COMMISSION OF ARCHITECTURAL REVIEW STAFF REPORT December 19, 2017, Meeting

7. COA-027097-2017 (Eastern Edge Development) 2108 ½ East Broad Street
St. John's Church Old and Historic District

Project Description: Construct a new 3-story single family dwelling.

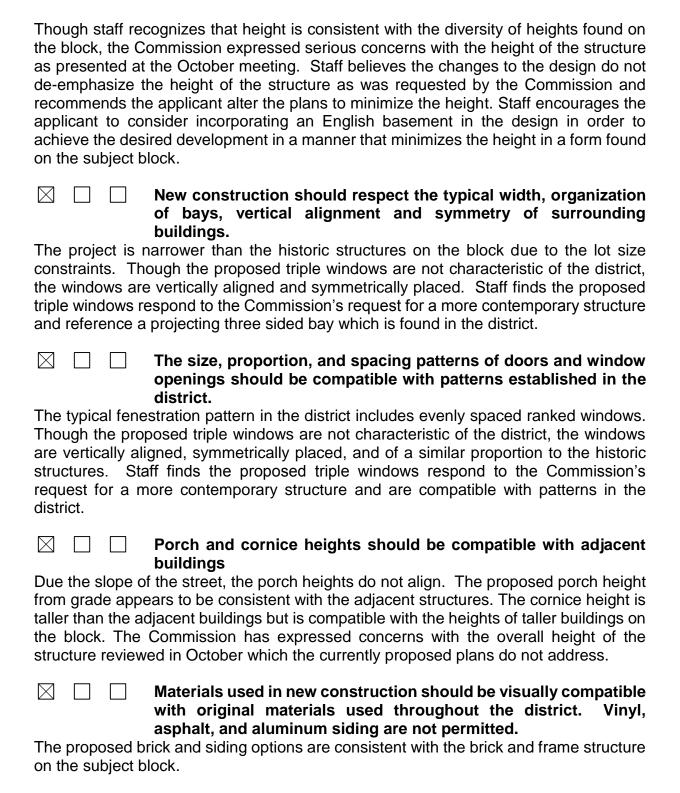
With this application, the applicant is proposing a 3-story structure to be clad in brick or composite siding. The fenestration of the façade consists of three attached openings centered on the elevation and recessed from the building wall on each level. The applicant is proposing a front porch and a second story balcony on the façade. The structure will have a front yard setback to align with the adjacent homes and 2'-4" and 1'-2" side yard setback. Per the site plan, the applicant is proposing an inset side porch and a large rear deck.

S=satisfies	D=does not satisfy	NA=not applicable
The front yard s	New infill construction should respect side yard setback patterns in the surrou setback matches the adjacent properties. Insistent with the adjacent structures. The d setbacks and will require a variance.	nding district The minimal side yard
	Where the adjoining buildings have diffe setback for the new building should be be pattern for the block sistent with the adjacent buildings.	
	New buildings should face the most pro	ominent street bordering
the site The structure addresses East Broad Street.		
New construction should use a building form compatible with that found elsewhere in the district. Form refers to the combination of massing, size, symmetry, proportions, projections and roof shapes that lend identity to a building. The tall and narrow structure is not a building form commonly found in the district. The proposed design details were in response to the Commission's request for a more contemporary design. The applicant has include a front porch, a symmetrical façade, and a cornice which are characteristic of the district. The proportions of the proposed front porch in relation to the façade are not characteristic of the subject block as the porches on the surrounding structures are either full façade porches or small entry porticos. The proposed structure is longer than the adjacent buildings though it has a depth similar to the new construction at 2102-2104 East Broad Street.

New construction should incorporate human-scale elements such as cornices, porches and front steps. The proposed project incorporates human-scale elements including a front porch, a simple cornice, and front steps.		
The proposed pr	New construction should respect surrounding buildings roject is taller than the adjacent structures,	and the height difference

The proposed project is taller than the adjacent structures, and the height difference with respect to 2108 East Broad Street is exaggerated due to the change in grade. The structures on the subject block of East Broad Street vary in height as there are several taller homes with English basements on the south side of the street in addition to the two story historic homes and three story new construction on the north side of the street.

The following items will need to be included for final review (please refer to the Commission's New Construction Checklist and Required Dimensions document for additional details):

1. Fully dimensioned elevations

- 2. Roof plan
- 3. List of windows and doors to include size, material, and design
- 4. Description of all materials (attach specification sheets if necessary)
- 5. Site plan to include parking, trash, and mechanical equipment locations
- 6. Dimensioned context elevation
- 7. Statement of how the *Richmond Old and Historic District Handbook and Design Review Guidelines* informed the proposed work.
